Pedestrian Crossings Over Nannup & Carlotta Brooks

Concept Design Report

Client: Main Roads Western Australia

Main Roads WA comments

Figure 2 Shire's proposed footpath route

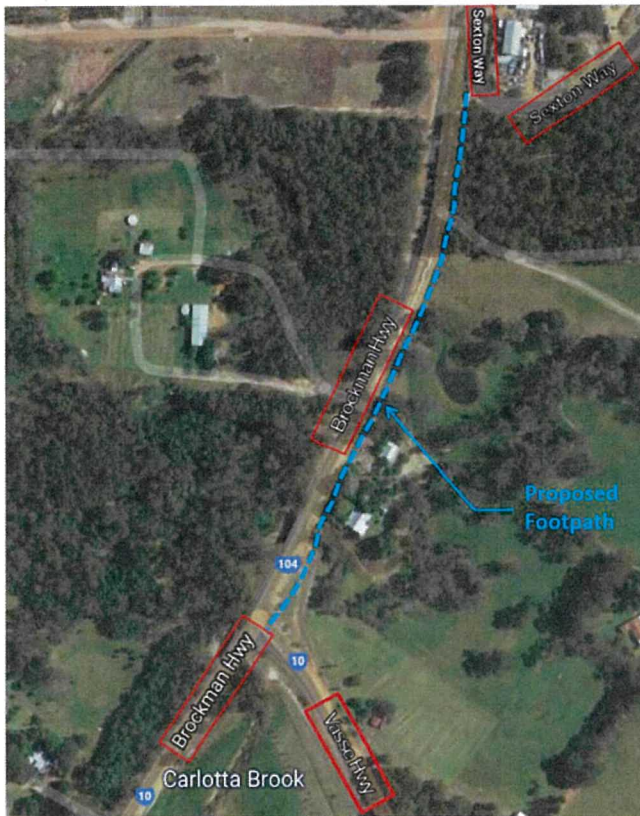
9	Section 1.1, 1 st paragraph, 5 th sentence – change to “ ... pedestrian pathway on the bridge <u>resulting in pedestrians using the</u> existing traffic lanes to cross Nannup Brook.”	Amended
10	Section 1.1, 2 nd paragraph, 1 st sentence – change to “Bridge 0257A carries <u>Brockman Highway over Carlotta Brook</u> (refer Photo 2).”	Amended
11	Section 1.1, 2 nd paragraph, 5 th sentence – change to “ ... on the bridge <u>resulting in pedestrians</u> using existing traffic lanes ..”	Amended
12	Section 5.2, 2 nd sentence – change to “ ... existing footpath alignment <u>south of Sexton Way</u> ...”. Also, refer to a plan showing the Shire’s proposed footpath route. Where is Sexton Way – show on plan.	Amended Plan view added

Figure 3 Space Available between Bridge 0256A & Adjacent Property

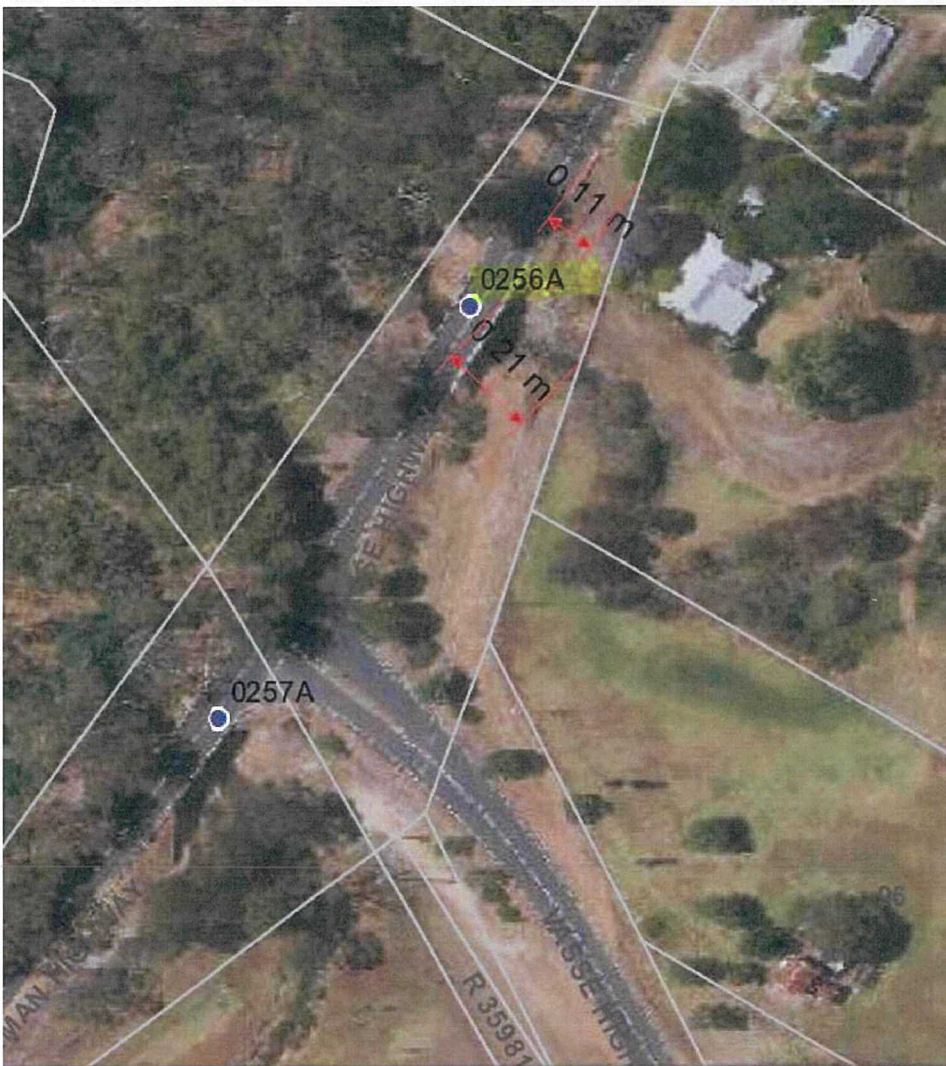
No.	Comment	Response
13	Section 5.4, Photo 4 – change caption to “Services at Abutment 1 LHS on Bridge 0256A (as viewed from Abutment 2)”	Amended
14	Section 6.1, 1 st paragraph – spelling “Abutment”	Amended
15	Section 6.1, Figure 2 – enlarge so that details are easier to read.	Amended
16	Section 6.1, 2 nd paragraph – the 1m horizontal separation is no necessary as long as the detailing is suitable.	Noted
17	Section 6.2.1, 1 st paragraph – change “stringer” to “beam” x2.	Amended
18	Section 6.2.1, 2 nd paragraph, 2 nd sentence – generally the wingwalls would be cut back and the footpath supported on concrete footings behind the wingwalls.	Noted. Report updated.
19	Section 6.2.1, 3 rd paragraph, 2 nd sentence – change to “Also , the waterways area will not be <u>reduced</u> in this option.”	Amended
20	Section 6.2.2 – clarify that the Unibridge options are to be installed adjacent to Bridge 0256A and 0257A on the LHS.	Added

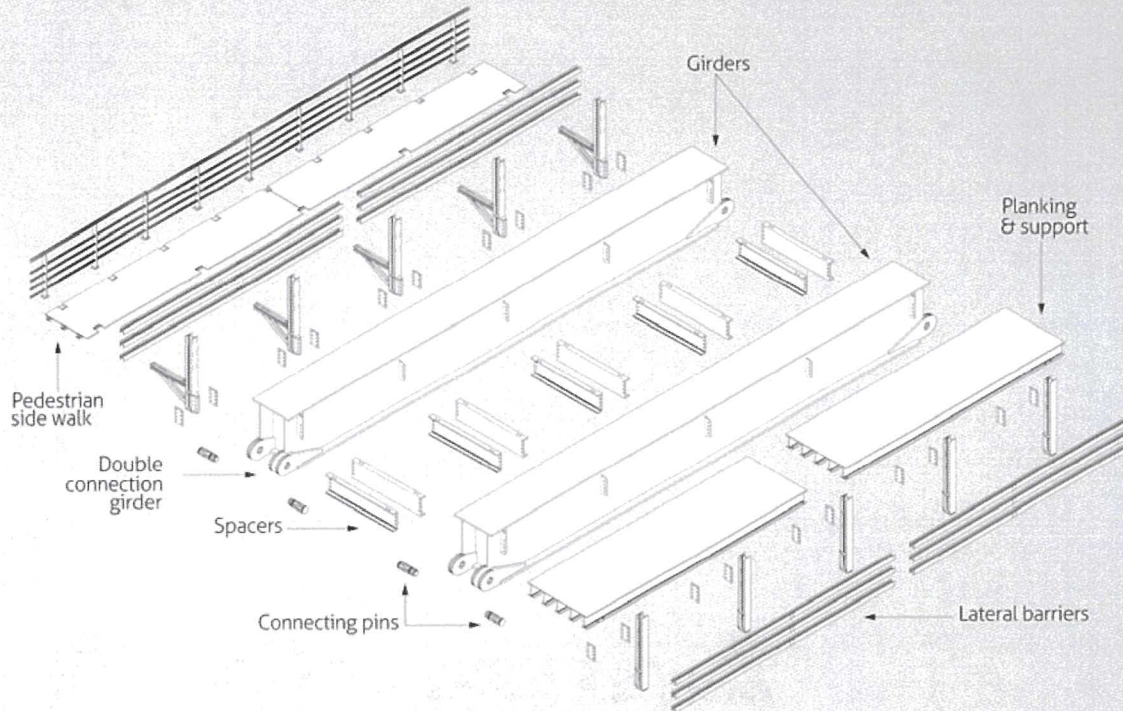
21	Section 6.2.2, 5 th paragraph, 2 nd sentence – change to “ ... may <u>become partially</u> flooded ...”	Amended
22	Section 6.2.2, 5 th paragraph, 3 rd sentence – change to “The bridge superstructure will also <u>be</u> subjected ...”	Amended
23	Section 6.3, Table 1 – the weighting has not been applied to the scores. Clarify that a high score is a good score. The results of the ratings put the Unibridges adjacent to Bridge 0256A and 0257A is the preferred option. However, this is not a suitable option for Bridge 0257A as discussed in Section 6.2.1. Option 1 likewise is not suitable for the same reasons. The rating scores do not help the decision making process so should be removed. The standalone crossings away for Bridge 0256A and 0257A appear to be preferred and should be carried into the 15% design stage. The crossings could be culverts or bridges.	Rating score table removed. Report updated. A discussion section has been added in the report to talk about the more suitable option among the three proposed options.
